SAFETY RECALL BULLETIN

SUBJECT: FLOOR HARNESS SAFETY RECALL		No: SR-08-002
		DATE: March, 2008
		MODEL: 2007 - 08 Outlander
CIRCULATE TO:	<input type="checkbox"/> GENERAL MANAGER	<input checked="" type="checkbox"/> PARTS MANAGER
<input checked="" type="checkbox"/> SERVICE ADVISOR	<input checked="" type="checkbox"/> SERVICE MANAGER	<input checked="" type="checkbox"/> TECHNICIAN
	<input checked="" type="checkbox"/> WARRANTY PROCESSOR	<input checked="" type="checkbox"/> SALES MANAGER

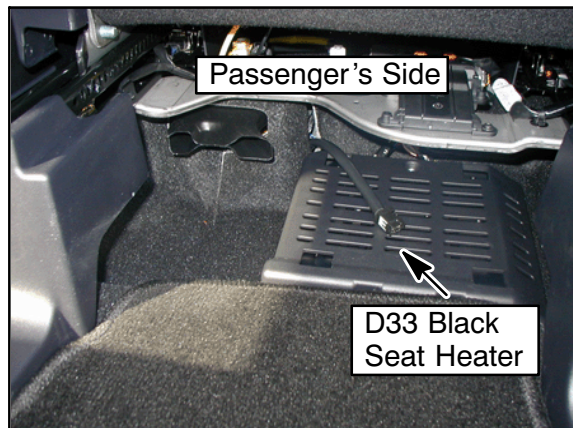
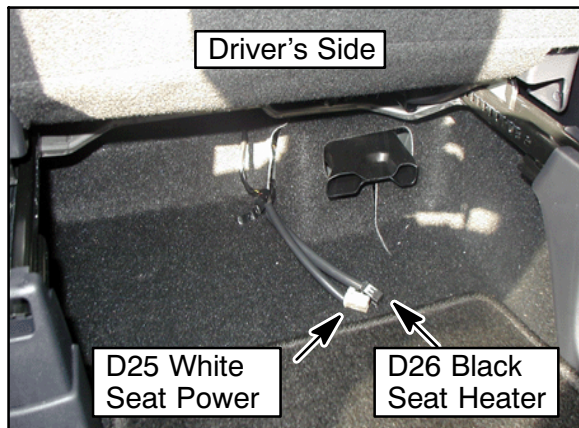
3. Reach through the carpet cutouts as illustrated and locate the loose connectors. There are two connectors for the driver's side (D25, 2 pin, power seat & D26, 4 pin, seat heater) and one connector for the passenger's side (D-33, 4 pin, seat heater).

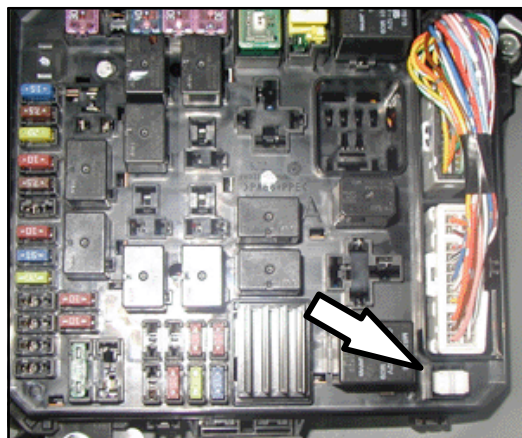
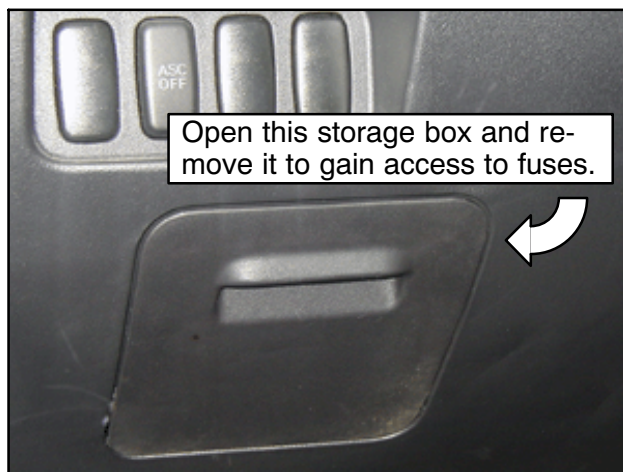
NOTE: If you find a melted connector, remove multi-purpose fuse #24 for the power seat, located in the fuse panel behind the storage box on the driver's side lower dashboard. Retain the fuse for reinstallation when repairs are completed. Cut the melted connector from the harness and wrap the loose ends of the wires separately with electrical tape, and then tape the power seat and seat heater harnesses together before proceeding. Inspect if the removed fuse has blown. If it has, replace it.

Passenger's Side

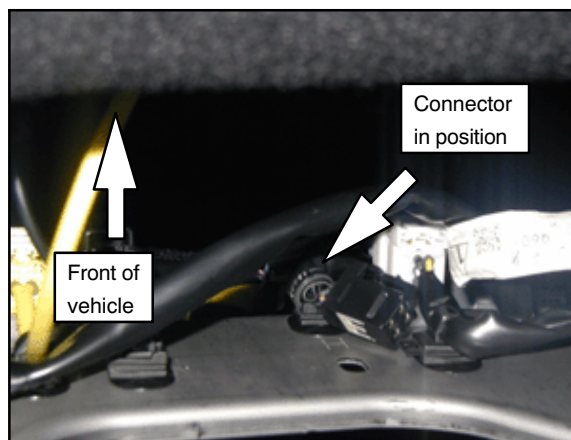
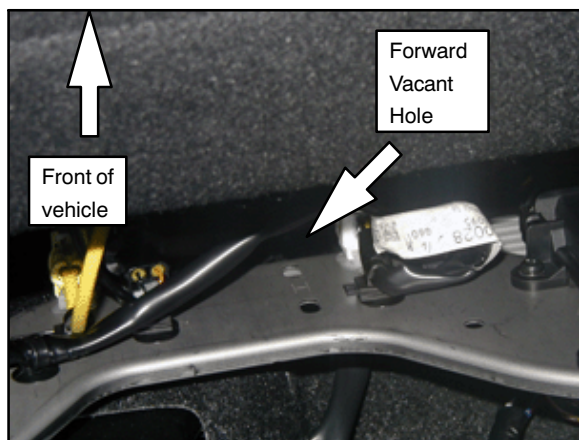
7. Attach the tie strap (MU800001) to the harness approximately 1/4" (5mm) from the end of the harness shielding as shown. Cut the excess from the tie strap and discard it.

8. Using the following photos as a guide, route the harness up the front side of the seat reinforcement and secure the tie strap to the vacant forward hole in the reinforcement.
